Technical Warning Notice

Subject: Cord Controller inspection circuits

Drawing / Job No		2503	
Cord Ref.	Customer Ref	Date	
3-SD2D	B273	21.09.99	
Programme No		Sheet	Next
		2	2A

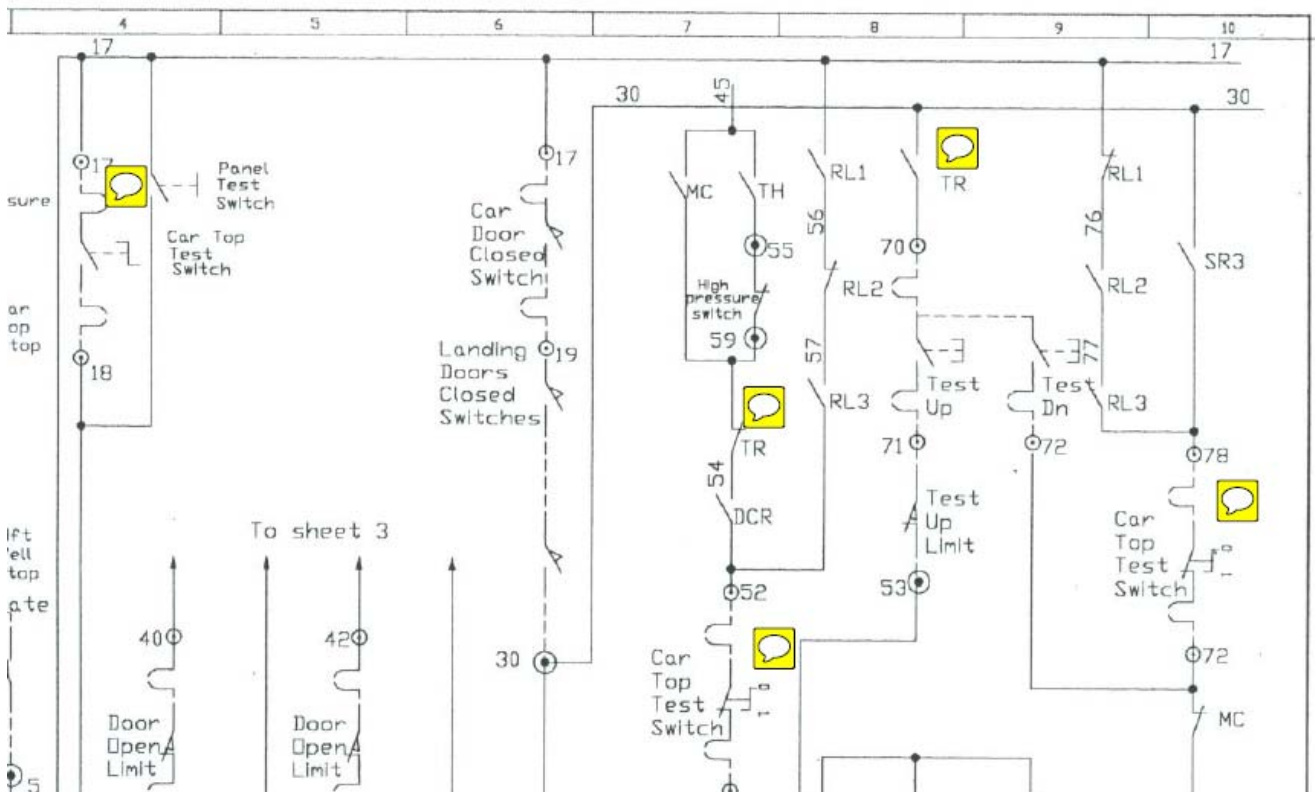
The wiring diagram (left) depicts the test relay, as the relay is required to be energised to activate inspection control it is not 'fail safe' any interruption in the supply to the relay or defects in wiring or components will de-energise the circuit placing the unit back on to normal control potentially jeopardising the safety of any engineer who may be in the lift shaft.

- On the next visit to the machine room establish if the control panel on a unit is a Cord panel.
- Examine the legend (on the wiring diagram) for the date and the wiring diagram number.
- Examine the wiring diagram circuits highlighted below if they are as shown then remedial action is required, the *unit is safe to be left in normal service*.

- If access to the shaft area is required the inspection control cannot be relied upon and the lift car must be positioned and isolated before working on it.
- This fault should be raised and the defect highlighted to your Manager for local site remedial action, fit a temporary warning sign to the car top controls and note in the observations section of the log card.
- A revised wiring diagram is required for the site, this will detail the wiring modifications that are required to upgrade the associated circuits to ensure they are 'fail safe'. To obtain a revised wiring diagram, please contact Cord Controls with the wiring diagram number and date from the legend (see above) at:
